Serial: RA-21-0272

Brunswick Steam Electric Plant, Unit Nos. 1 and 2
Renewed Facility Operating License Nos. DPR-71 and DPR-62
Docket Nos. 50-325 and 50-324

Subject: Supplement to License Amendment Request to Revise Technical Specifications to Adopt Risk-Informed Completion Times TSTF-505, Revision 2, "Provide Risk-Informed Extended Completion Times – RITSTF Initiative 4b"

Figure 1 – Comparison of BNP GMRS to the Safe Shutdown Earthquake (SSE), the Review Level Earthquake (RLE) at the Surface, and the IPEEE HCLPF Response Spectra (IHS) at the Control Point Assessed in the IPEEE.

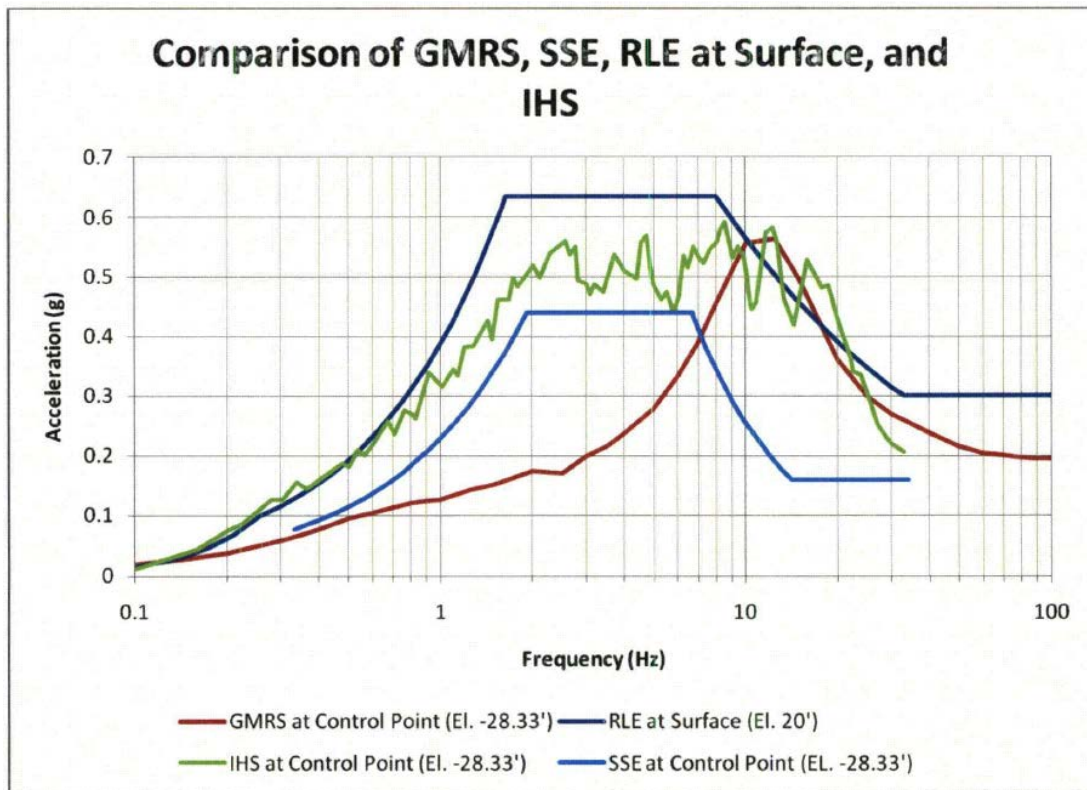
In addition, the seismic bounding analysis used an average of 5 frequencies of seismic hazard curves (PGA, 10, 5, 2.5 and 1 Hz), instead of an average of 4 frequencies of seismic hazard curves (PGA, 10, 5, and 1 Hz) proposed in Generic Issue 199. The licensee compared the difference between the two methods, with a non-conservative value from the 5-frequency method (2.81E-6 vs 3.46E-6 for SCDF and 1.35E-6 vs 1.67E-6 for SLERF penalties). However, the licensee did not provide the rationale for selecting a non-conservative averaging method.

- i. *Provide justification of why the spectral ratios developed from the RLE are applicable to the seismic hazard curves used in this application.*
 - ii. *Alternatively to Part (i), if the justification cannot be provided, calculate the spectral ratios based on the seismic hazard curves used for this application and use them to obtain and provide updated seismic penalty values.*

In response to the 50.54(f) letter, a BNP site-specific seismic hazard estimate has been developed (Reference 3) using EPRI guidance (i.e., the SPID) (Reference 8). The NRC further requested that interim actions be taken for plants whose updated ground motion response spectrum (GMRS) exceeds the design basis safe shutdown earthquake (SSE) in the spectral frequency range from 1 to 10 Hz. The GMRS for BNP exceeds the SSE at higher frequencies (as shown in Figure 1), so an evaluation of beyond design basis ground motions was performed utilizing data from the IPEEE (Reference 5). The IPEEE was reviewed for adequacy utilizing the guidance provided in the SPID, and the IPEEE plant-level HCLPF response spectrum (IHS) was included for screening purposes. The SSE, RLE, and the resulting IHS are plotted against the GMRS in Figure 1.

In nearly the entire 1-10 Hz region, the IHS at the plant control point exceeds the GMRS. There is a minor narrow band exceedance of the GMRS over the IHS in the 9.7-10 Hz region. At 10 Hz, the GMRS exceeds the IHS by approximately 9% which is within the 10% limit required by the SPID. The SPID also requires that the average ratio in the adjacent 1/3 octave bandwidth (1/6 on either side) is less than unity. Since the seismic risk evaluation screening in the SPID is limited to the 1-10 Hz region, only the 1/6 octave bandwidth below 10 Hz was evaluated. The area created between the IHS and the GMRS from 8.91 Hz to approximately 9.7 Hz is greater than the area created between the GMRS and the IHS from approximately 9.7 Hz to 10 Hz. Therefore, the average ratio of the GMRS to IHS is less than unity and this exceedance is considered acceptable (Reference 3).

The RLE response spectra anchored to 0.3g PGA was used as the seismic demand response curve in the IPEEE. The GI-199 assessment used this RLE demand curve as the lower bound on the actual HCLPF capacity of the plant level fragility curve (per table C-1 of GI-199 [Reference 4]) in order to establish the basis of plant level fragility curve parameters from the IPEEE information.

Figure 3 – BNP Plant Level Fragility for the Review Level Earthquake (RLE) (0.3g)

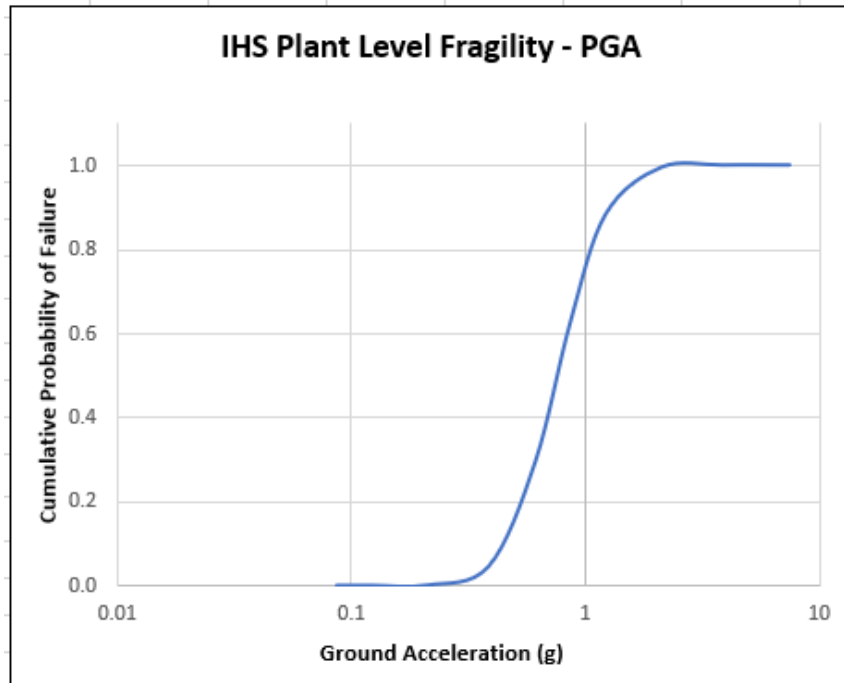
- i. Provide the rationale for selecting a non-conservative averaging method.*
- ii. Alternatively to Part (i), if the rationale cannot be provided, use an averaging method that is consistent with commonly accepted method and provide updated seismic risk penalty values.*

The BNP plant level fragilities at PGA for the RLE were calculated and are plotted in Figure 3 below. The cumulative probability of failure is 1.0 for ground accelerations greater than 5g. These values are inherently conservative as they represent the lower bound HCLPF capacity based on the most limiting component in the plant, and they are used as both the seismic conditional core damage probabilities (SCCDPs) and the seismic conditional large early release probabilities (SCLERP) for the SCDF/SLERF calculations.
